Access Compliance Report

Public Rights-of-Way

(Curb Ramps)

Intersection ID: 30419	Main Street: ELM_BEND_DR	Cross Street: FENWAY_DR	Location: SE
ADA ID: EC34AD27F5FE	Ramp Type: PerpDiag	Initial Pass/Fail: Fail	Overall Compliance: No
Severity Score: 13.75			
Codes/Mitigation Info/Possible Solution		Field Measurements/Component Compliance

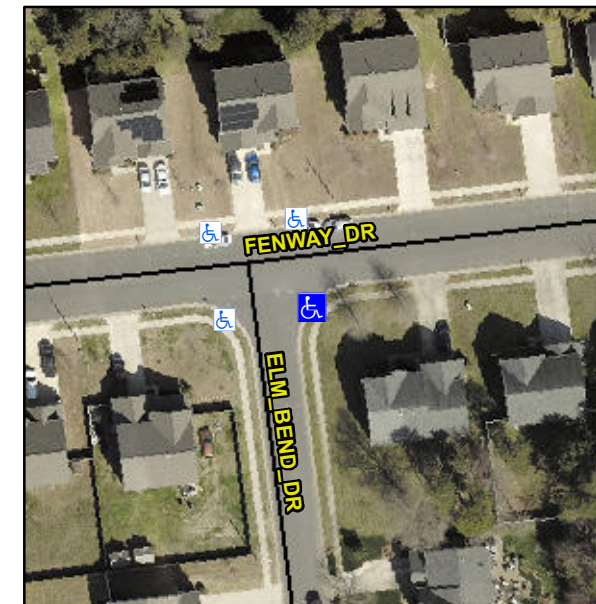
R304.2.2, R304.5.3

Compliance	Description	Data	Compliance	Description	Data
N/A	Ramp Length (in)	52.0	No	Ramp Slope (%)	9.2
Yes	Ramp Width (in)	48.0	No	Ramp XSlope (%)	3.3
N/A	Flare Type LT	N/A	N/A	Flare Type RT	N/A
N/A	Flare Slope LT (%)	N/A	N/A	Flare Slope RT (%)	N/A
N/A	Flare Traversable LT?	N/A	N/A	Flare Traversable RT?	N/A
N/A	Landing Length (in)	N/A	N/A	DWS Provided?	N/A
N/A	Landing Width (in)	N/A	N/A	DWS Contrast?	N/A
N/A	Landing Slope (%)	N/A	N/A	DWS Length (in)	N/A
N/A	Landing X Slope (%)	N/A	N/A	DWS Full Width?	N/A
N/A	Landing Curb? (Y/N)	N/A	N/A	DWS Offset (in)	N/A
N/A	Shared Landing?	N/A			
N/A	Gutter Ponding?	N/A	N/A	Gutter Slope (%)	N/A
N/A	Gutter Lip Ht (in)	N/A	N/A	Gutter X Slope (%)	N/A
N/A	Painted X Walk1?	No	N/A	Painted X Walk2?	No
	X Walk 1 Direction	To N		X Walk 2 Direction	To W
N/A	X Walk 1 Width (in)	N/A	N/A	X Walk 2 Width (in)	N/A
	X Walk 1 Slope (%)	1.8		X Walk 2 Slope (%)	2.5
	X Walk 1 X Slope (%)	1.1		X Walk 2 X Slope (%)	2.4

N/A	Ramp inside XWalk1?	N/A	N/A	Ramp inside XWalk2?	N/A
	Road Slope (%)	2.2	N/A	Clear Space?	N/A
	Road X Slope (%)	2.0	N/A	Clear Space to XWalk (in)	N/A
N/A	Any Obstructions?	N/A	N/A	Storm Grate/Utility Hazard?	N/A
	Obstruction Type			Storm Grate/Utility Type	
		N/A			N/A
		Yes		Surface Condition? (G/P)	Good

Remove & Replace Curb Ramp With Two New Directional Ramps or Equivalent.
